RS-08-012

Subject: Request For Amendment to Administrative Controls Section of Technical Specifications

Attachment 1: Evaluation of the Proposed Changes

Attachment 2A: Mark-up of Proposed Technical Specification Changes for Braidwood Station

## ATTACHMENT 2H

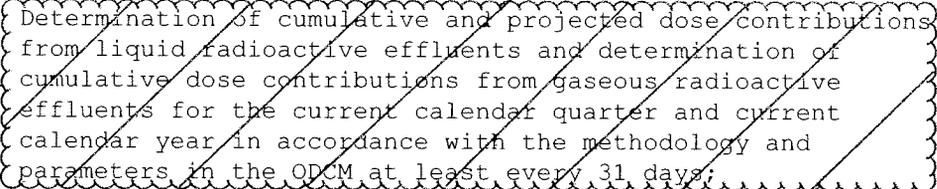
### Insert A

Determination of cumulative dose contributions from radioactive effluents for the current calendar quarter and current calendar year in accordance with the methodology and parameters in the ODCM at least every 31 days. Determination of projected dose contributions from radioactive effluents in accordance with the methodology in the ODCM at least every 31 days.

6-11b

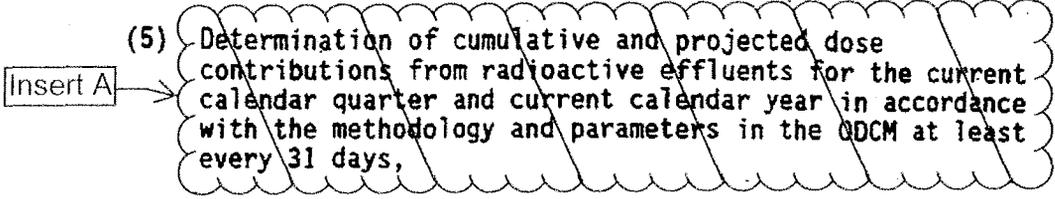
### Insert A
